# estimating bid document addendum 02

project: Cobscook Bay State Park - Shower Building & Utility Improvements  
Dennysville, Washington County, Maine BGS # 3473

date: 20 June 2024

1. Pole Barns - Sheet 1.5 Floor Plan 5-Bay and Sheet 2.5 Exterior Elevations 5-Bay.

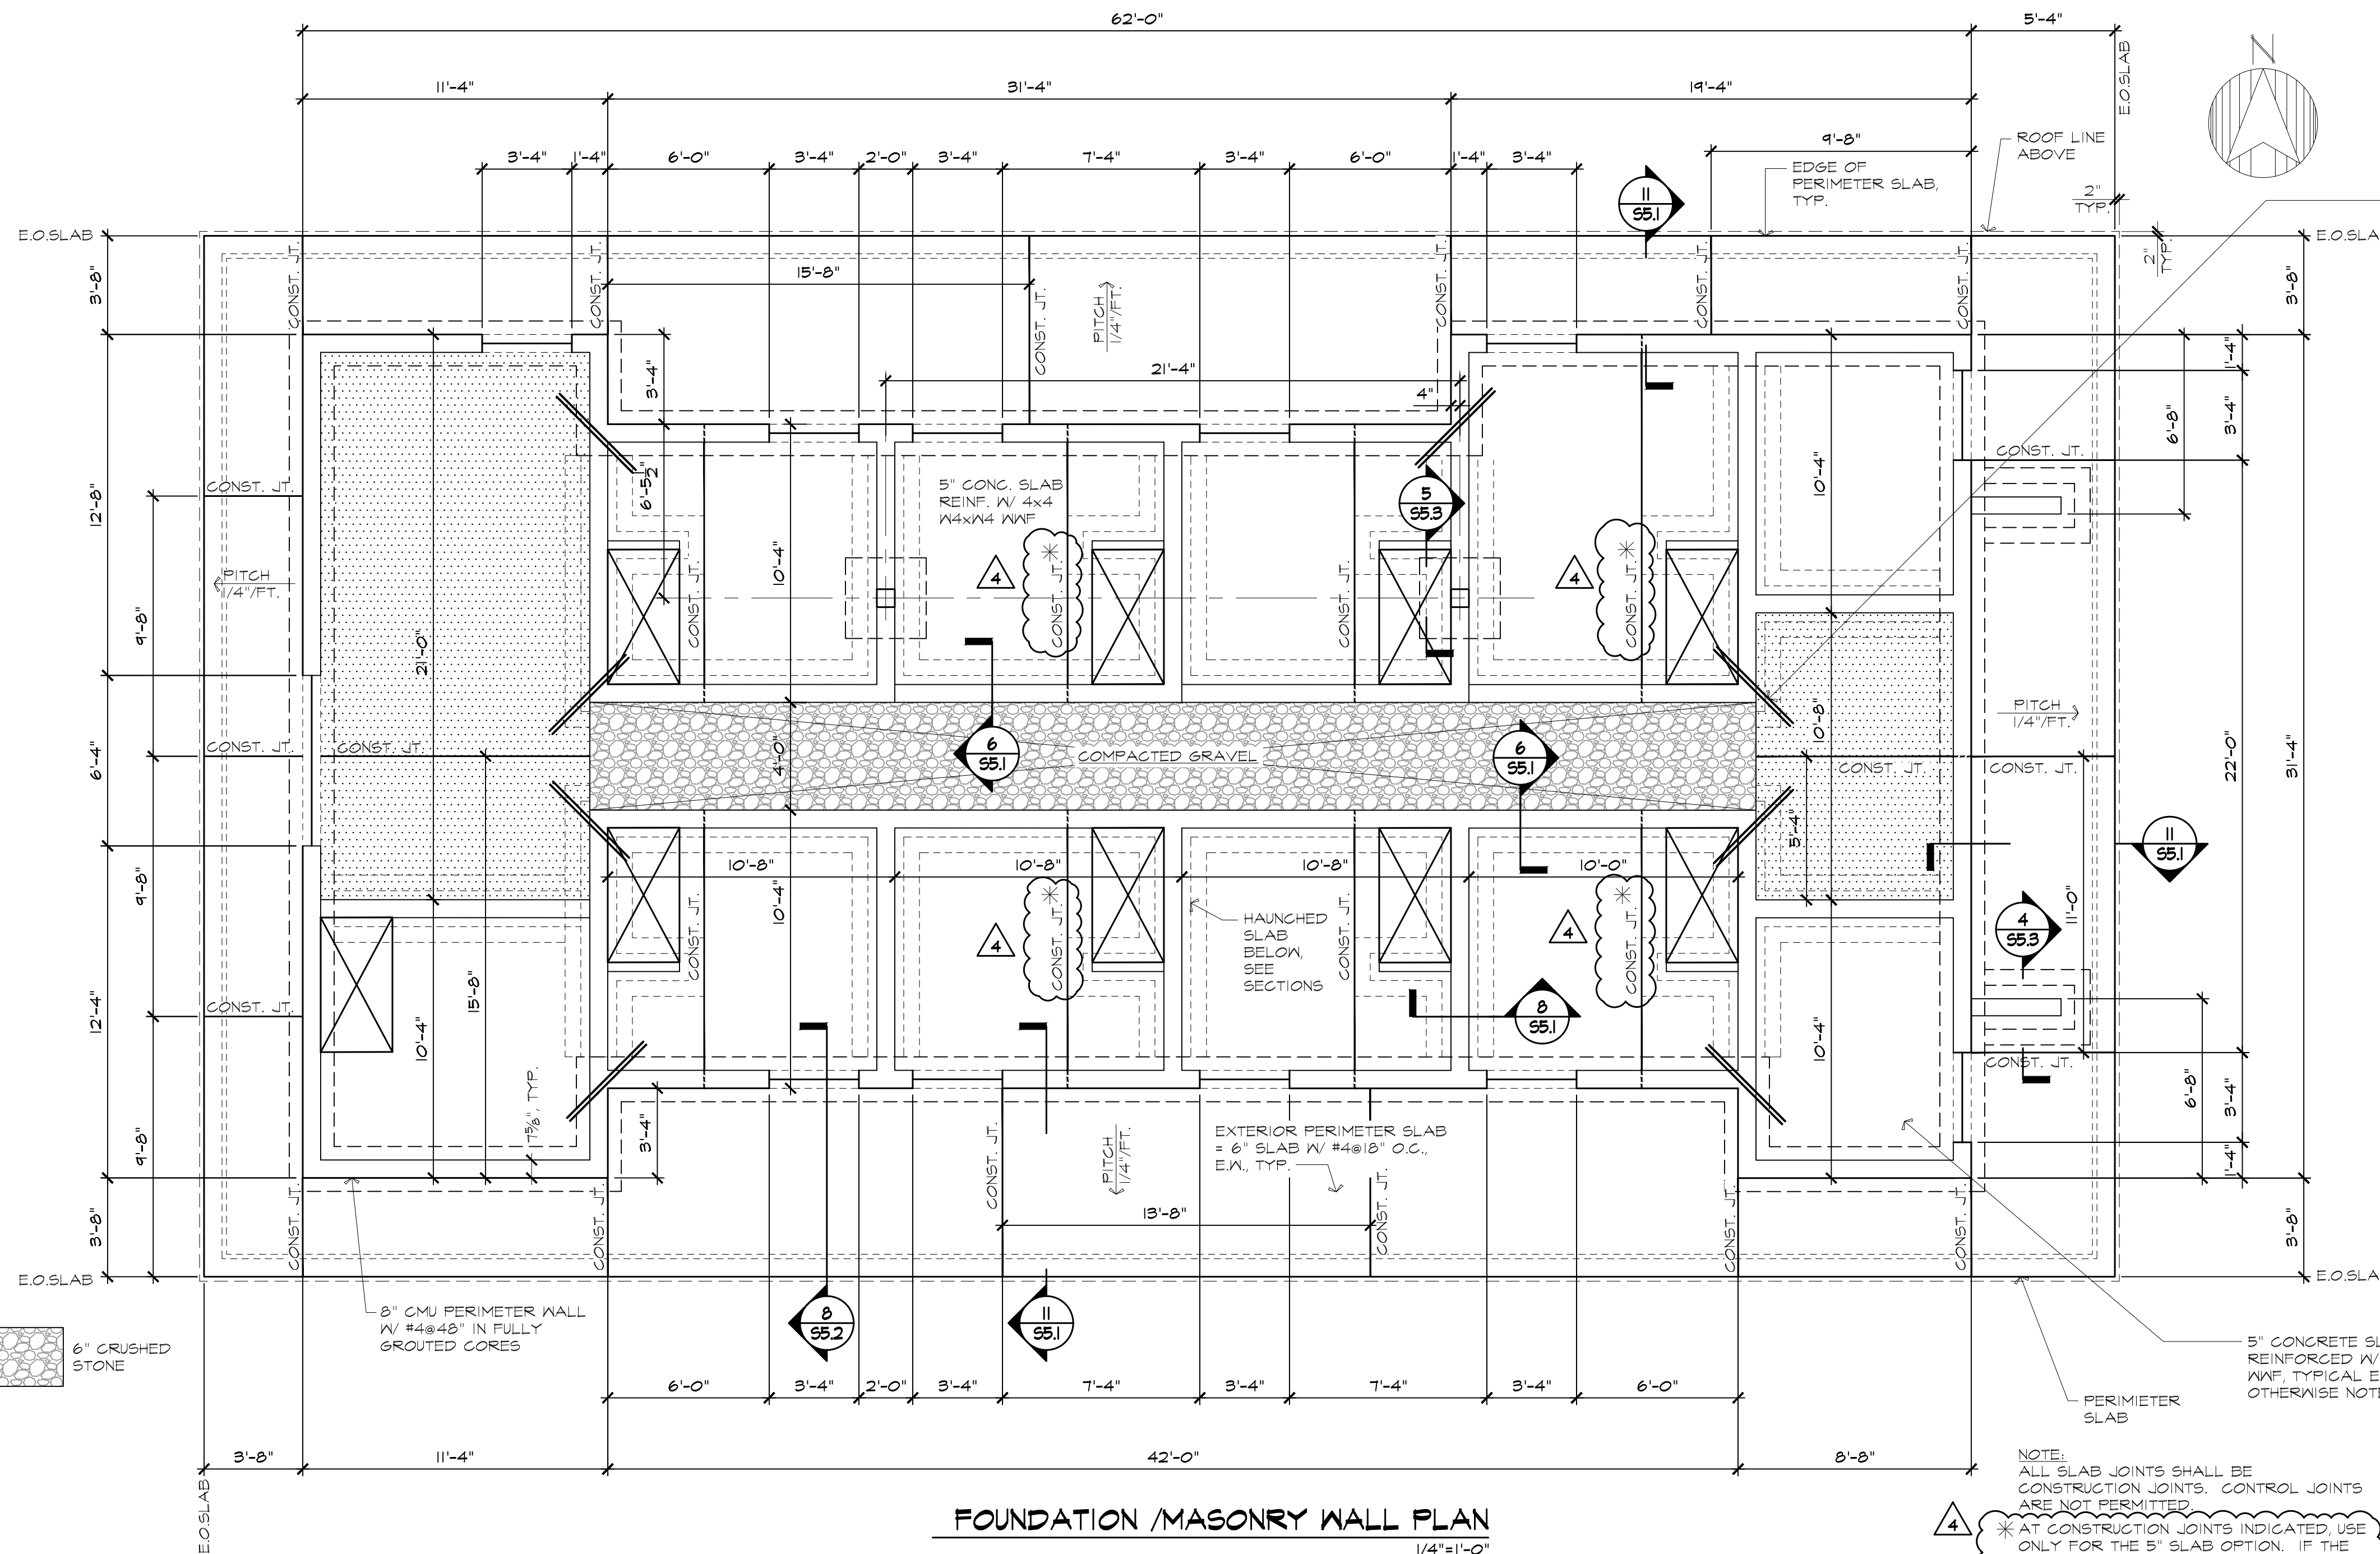
OMIT: Concrete landing pad, wood stairs, sliding barn doors, hinged man doors, and windows. Omitted openings to be framed consistent with standard wall framing, blocking and sheathing.

**FOUNDATION / MASONRY WALL PLAN**  
1/4"=1'-0"

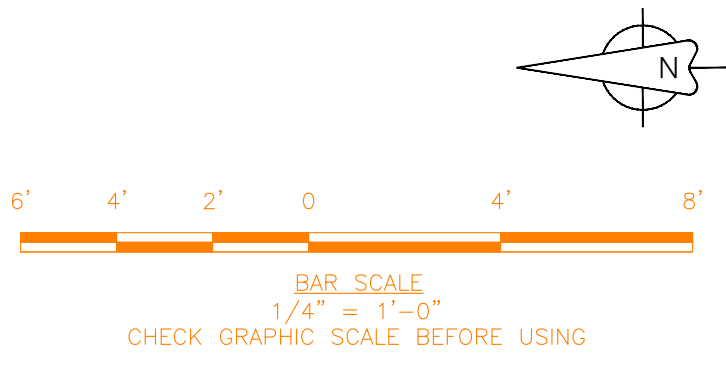
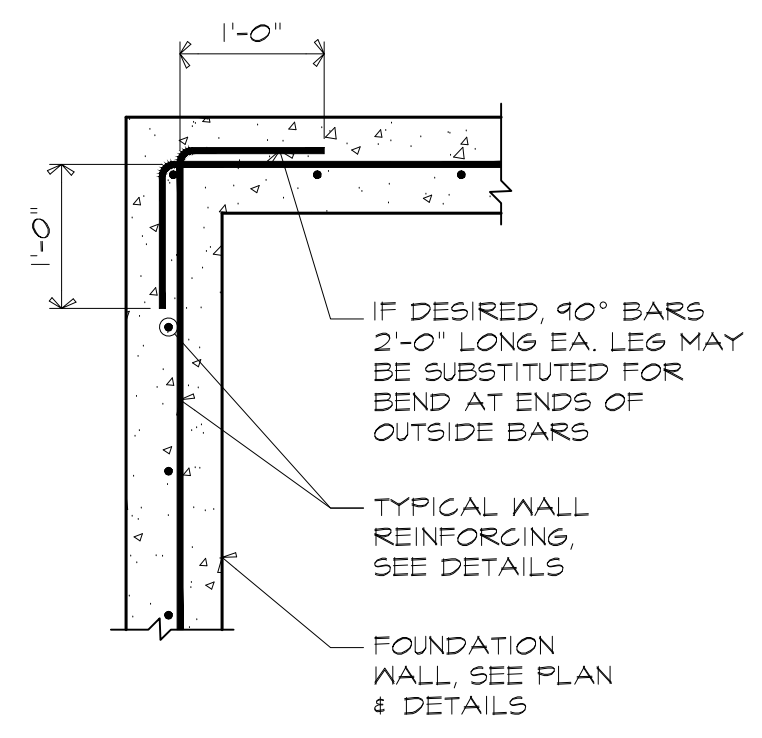
1. ADD: Revised S1.1 Foundation Plan dated 06.20.2024  
S5.1 Sections and Details dated 06.20.2024  
S5.4 Sections and Details dated 06.20.2024

PROVIDE (2)-#4 BARS x 4'-0" LONG CENTERED ON REENTRANT CORNERS AS INDICATED. LOCATE BARS 2" CLEAR FROM THE TOP OF SLAB AND 2" CLEAR FROM THE CORNER. ORIENT BARS AT A 45 DEGREE ANGLE FROM SLAB EDGES. SPACE BARS @ 2" ON CENTER.

NOTE:  
ALL SLAB JOINTS SHALL BE CONSTRUCTION JOINTS. CONTROL JOINTS ARE NOT PERMITTED.  
\* AT CONSTRUCTION JOINTS INDICATED, USE ONLY FOR THE 5" SLAB OPTION. IF THE UNIFORM 12" SLAB OPTION IS USED (NOTE 4) DELETE THESE JOINTS.
